**Re: DEP File #301-1376  
Plan Revision  
Jonatas Storck  
58 Massasoit Avenue, Sudbury, MA**

In response to comments received during the August 7, 2023 Conservation Commission meeting, we have revised the Design Plan and the Landscape Plan for 58 Massasoit Avenue, Sudbury, MA. The modifications include the following:

**PROPOSED HOUSE LOCATION PLAN**  
"58 MASSASOIT AVENUE"  
SUDBURY, MASSACHUSETTS  
APPLICANT:  
JBUS CHARLES, LLC  
15 EDWARDS LANE  
QUINCY, MA 02169

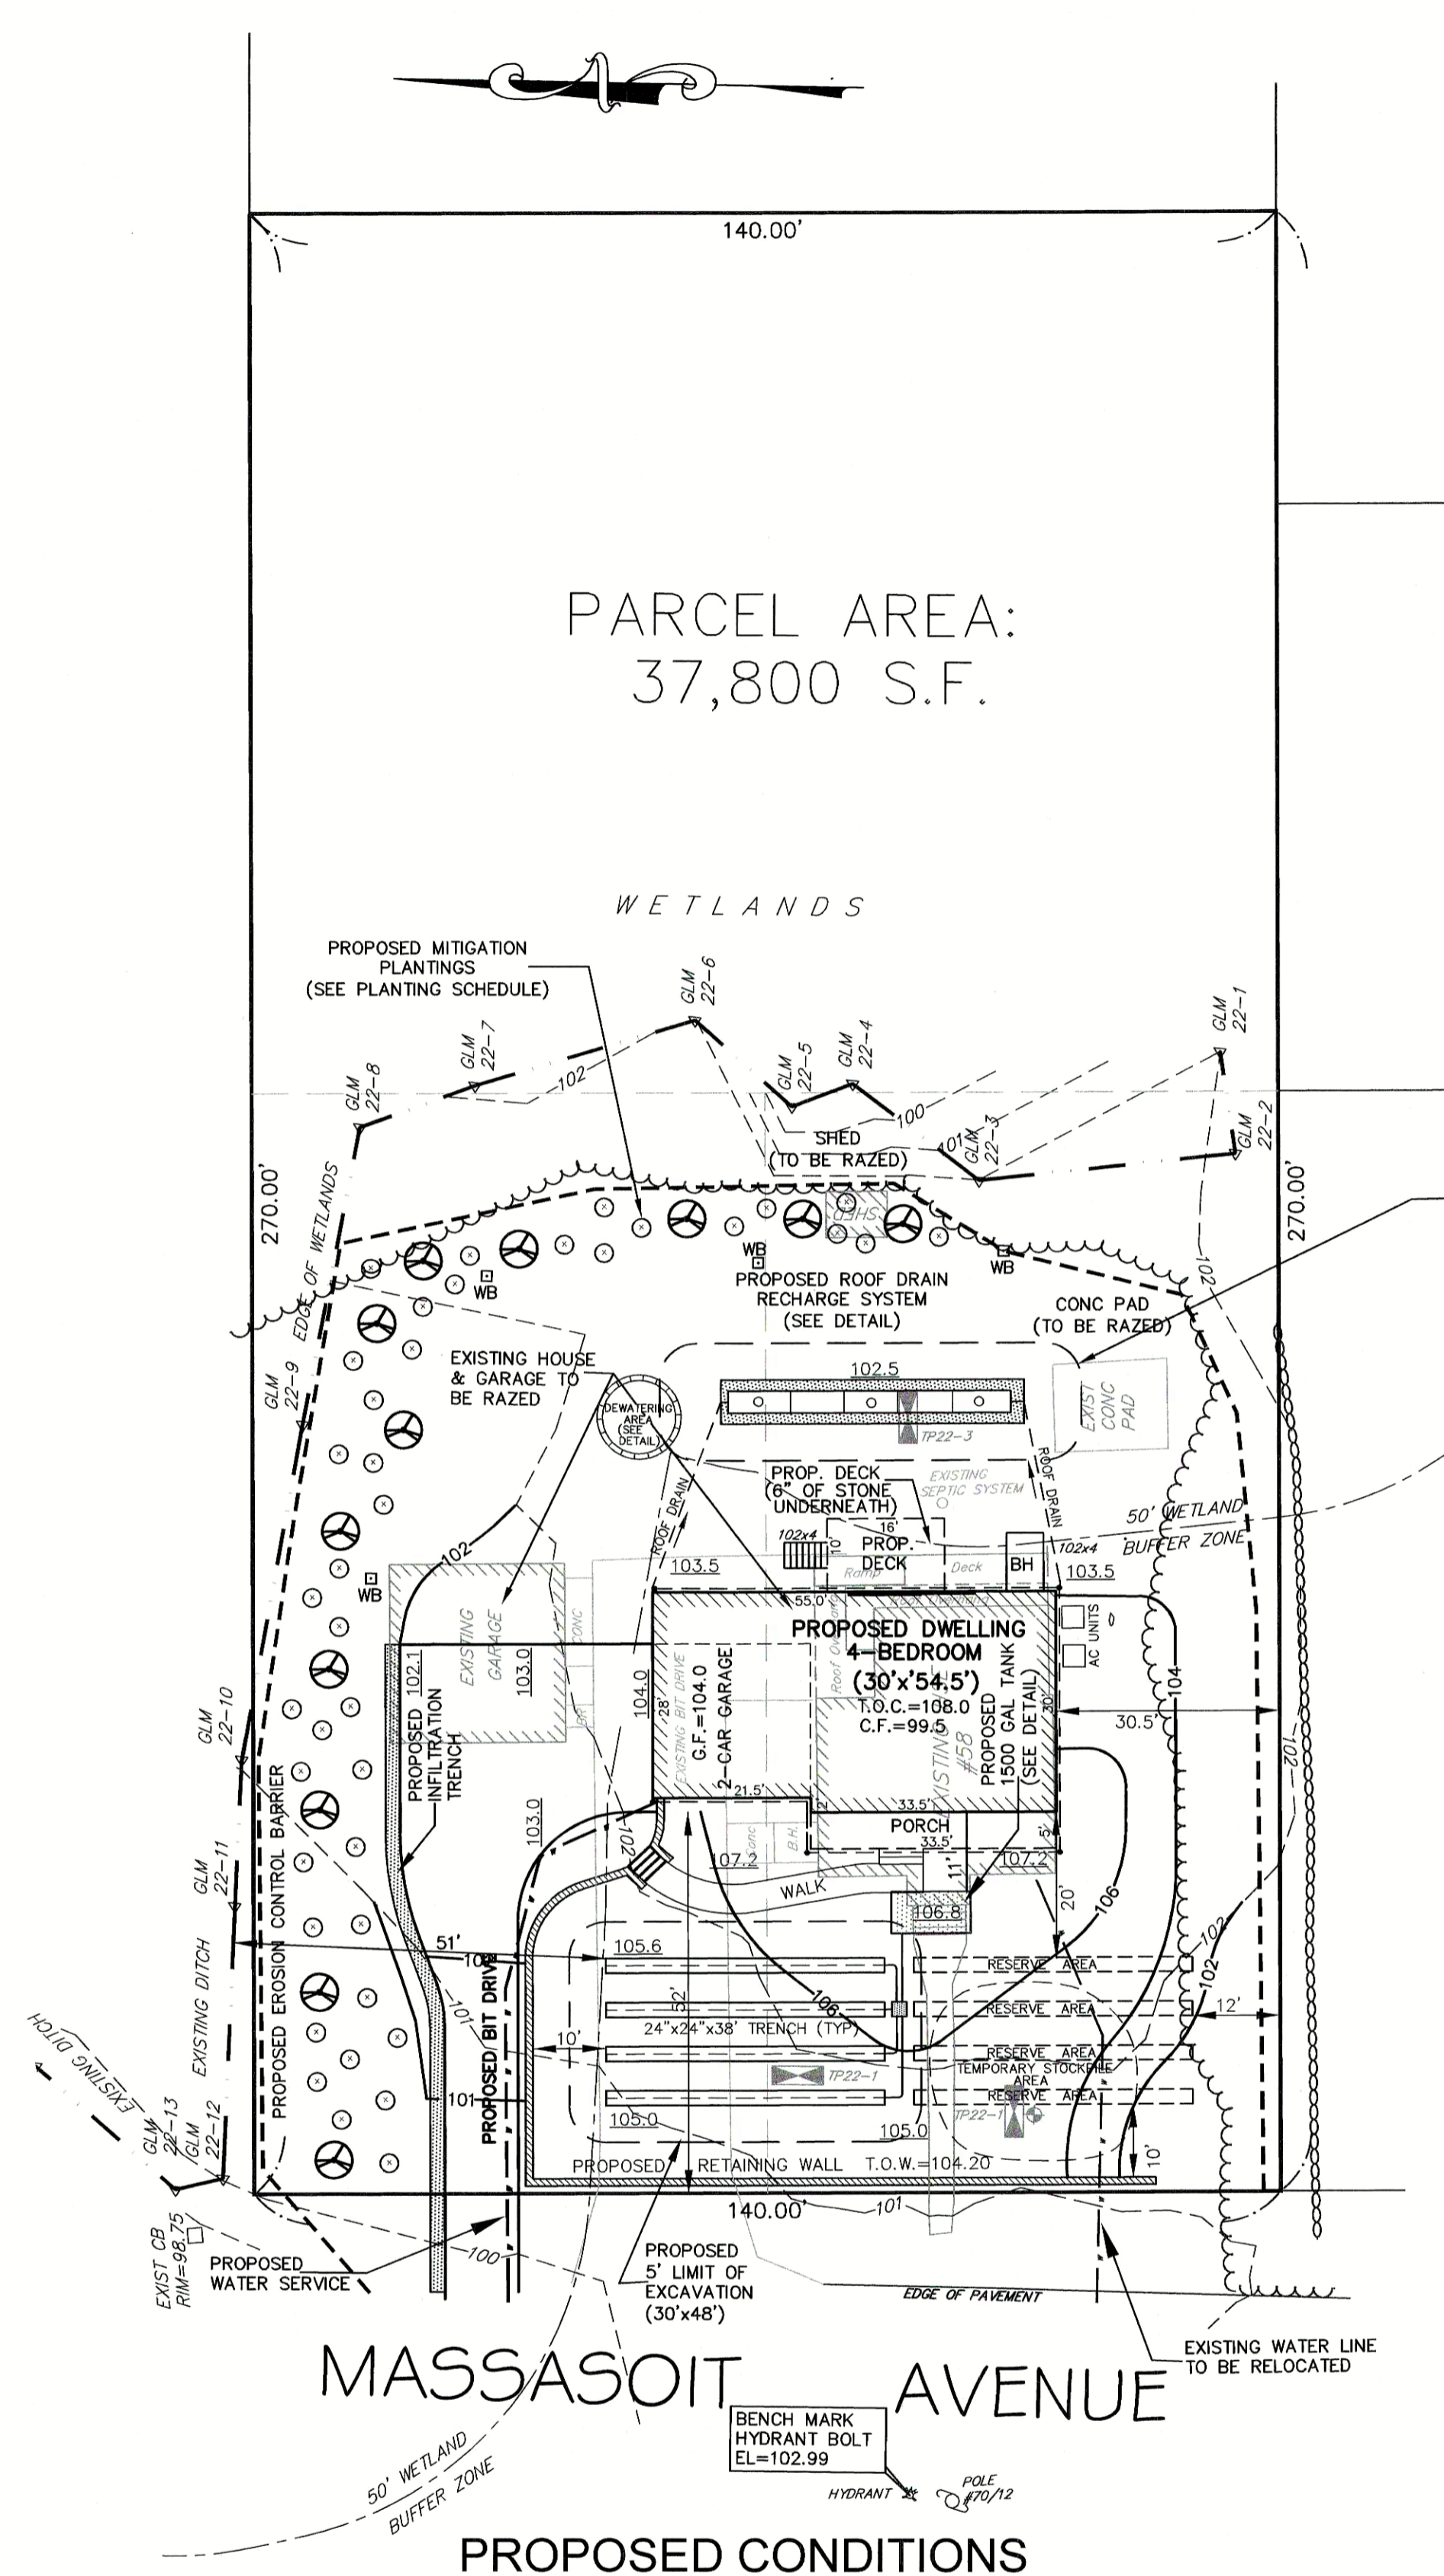
- The Landscape Plan has been revised to only reflect the landscape design for the front of the house, adjacent to the retaining wall and along the southerly property line. Attached please find six (6) copies of the Landscape Plan prepared by Steven Cosmos, dated 8-25-23.
- The Design Plan has been revised to add an additional chamber to the Roof Drain Recharger System and to add a note to the plan referencing the Landscape Architects Plan. Attached please find six (6) copies of the Design Plan prepared by GLM Engineering Consultants, Inc, dated 8-25-23.
